Inspection/Audit Photos

Location Name: QB ENERGY OPERATING LLC CHEVRON I01 697

Location #: 335693

Photo # 6658 Tank label has previous operators name

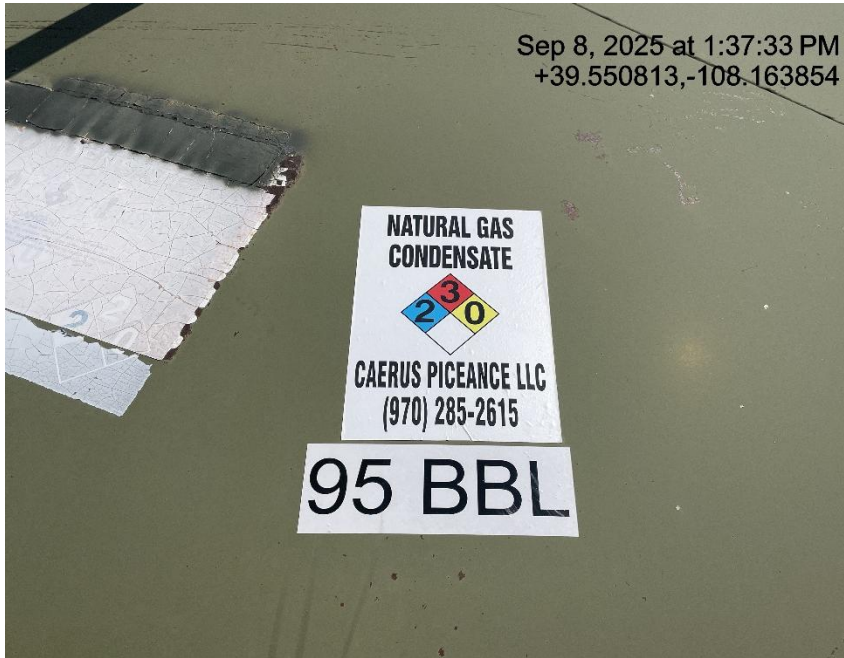
Photo # 6659 Tank labels have previous operators name

Photo # 6660 Tank labels have previous operators name

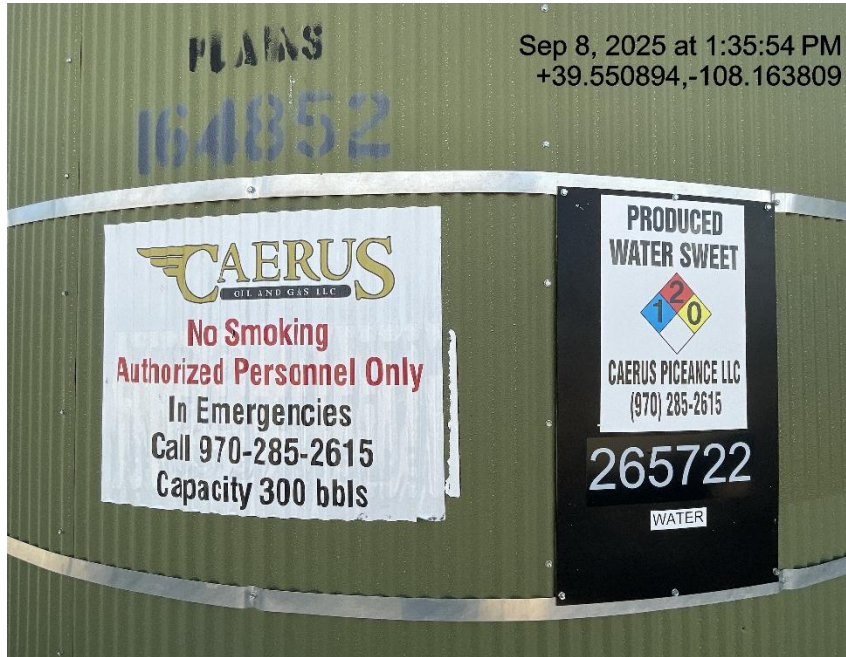
Photo # 6661 Battery sign has previous operators name
